ITEM 26. PARKING – COACH PARKING – SUSSEX STREET SYDNEY

TRIM RECORD NO: 2018/015349

Sussex Street, Sydney Proposed parking changes

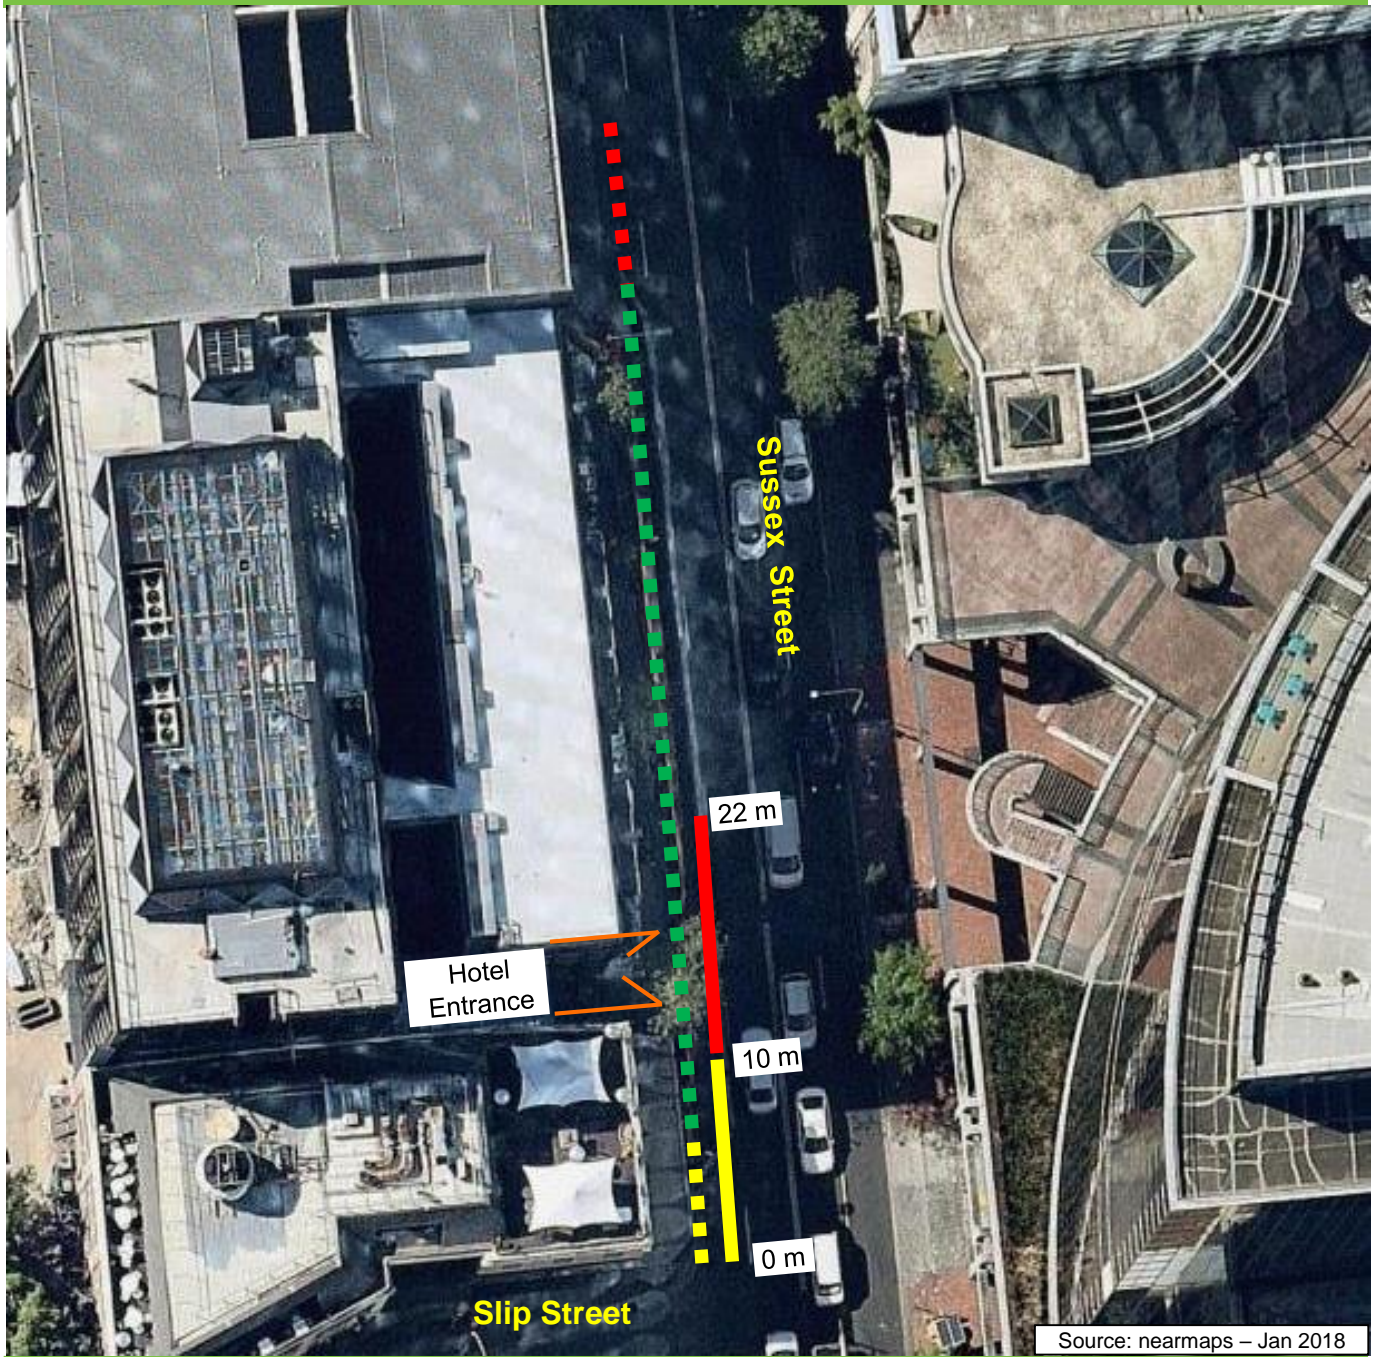
It is recommended that the Committee endorse the following reallocation of parking on the western side of Sussex Street, Sydney, north of Slip Street:

- (A) “No Stopping” between the points 0 metres and 10 metres (one car space); and
- (B) “No Parking Coaches Excepted 15 Minute Limit” between the points 10 metres and 22 metres (two parking spaces).

On-site inspection shows that it is suitable to reallocate 12 metres of kerb space at the entrance to the Hotel to “No Parking Coaches Excepted 15 Minute Limit”.

As part of the proposal, the existing “No Stopping” restriction, north of Slip Street, will be extended to 10 metres to comply with Roads and Maritime Services Technical Direction.
